Product Recombinant Antihemophilic Factor (FVIII), Kovaltry (BAY 81-8973)

Subject: Final (Addendum) Discipline Review Memo for Biological License
Application for Coagulation Factor VIII (Recombinant), STN: 125574/0
Kovaltry (BAY 81-8973)

Fig. 1. Plot of Peak area against Volume of (b) (4) solution added

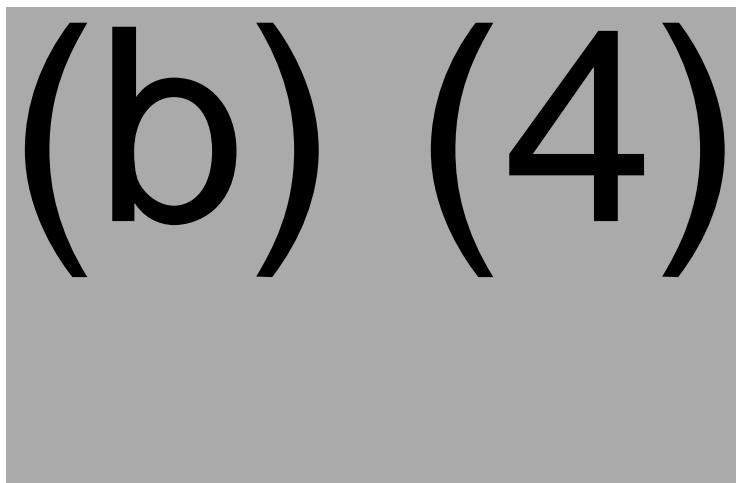
Region 4 (b) (4) Samples of (b) (4) was (b) (4) of that of 250 IU DP and are (b) (4) to demonstrate linearity of the method. Since this plot actually demonstrates

method accuracy but not linearity, we plotted (b) (4) against the volume of (b) (4) based on the data provided under Linearity/Accuracy Results for Region 4 of the validation report, Doc No. MVR-MV-BC393-0002.05. Since the (b) (4) volume is proportional to the amount of (b) (4), our calculation provides appropriate estimation of linearity. Our plot (Fig. 1) clearly shows that the level 6 (highest amount of (b) (4)) is outside the linear range of the assay. Considering between level 1 and level 5, corresponding to the (b) (4) solution, shown in Fig. 1, r^2 is (b) (4), which met the acceptance criterion of (b) (4)

The recovery within this range is (b) (4) which did not meet the acceptance criteria, (b) (4). The (b) (4) which is overestimation in the product, which is acceptable. The LOQ calculated from the slope of the plot (without level 6) and residual standard deviation was found to be (b) (4).
